**Flood Control Project Maintenance
Levee Inspections**

Maintenance Issue Types Only, Levee Inspection Report By Mile - Spring 2018

Lake County Watershed Protection District

Waterway	Bank	Unit Miles	Inspection Start/End	Inspector
Unit No. 01 Middle Creek	Left	3.35	04/12/2018 04/12/2018	Bob Duffey

Photo 1 of 2 : LEVAL_SP_2018_18_1398.jpg

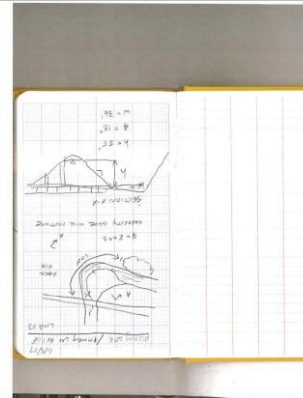
LM Start	0.99	Rating **	A/W	Issue No.	11
LM End	1.00	Issue Type +	Ma	Location *	
Category	Supplemental			GPS Latitude/Longitude	
				Start	End
Item	2017 Storm Damage			39.179715 °	39.179916 °
				-122.896926 °	-122.896970 °
DWR ID	DWR_NA0009_04_f_2017_11				
Comment Code					
Inspector Comment					
Levee Evaluation Comments					
Description:					
Site ID No:18					
Site Designation:LMA-3					
Repair Type: Erosion					
Rating:Critical					
Field Date:6/5/2017					
Notes: Erosion begins at the edge of the patrol road. Slope is covered in loose gravel, washes out every high water season.

Photo 2 of 3 : UCIP_SP_2018_26891_49681.jpg

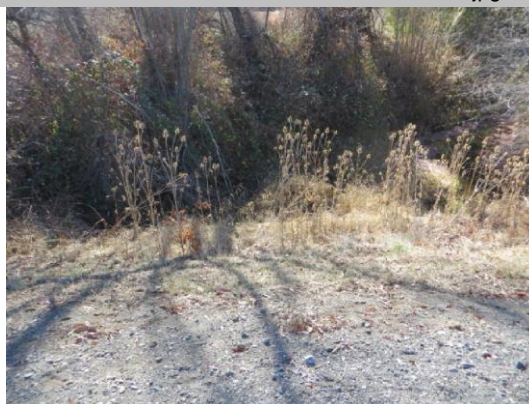
Outlet visible at concrete headwall on LS toe.
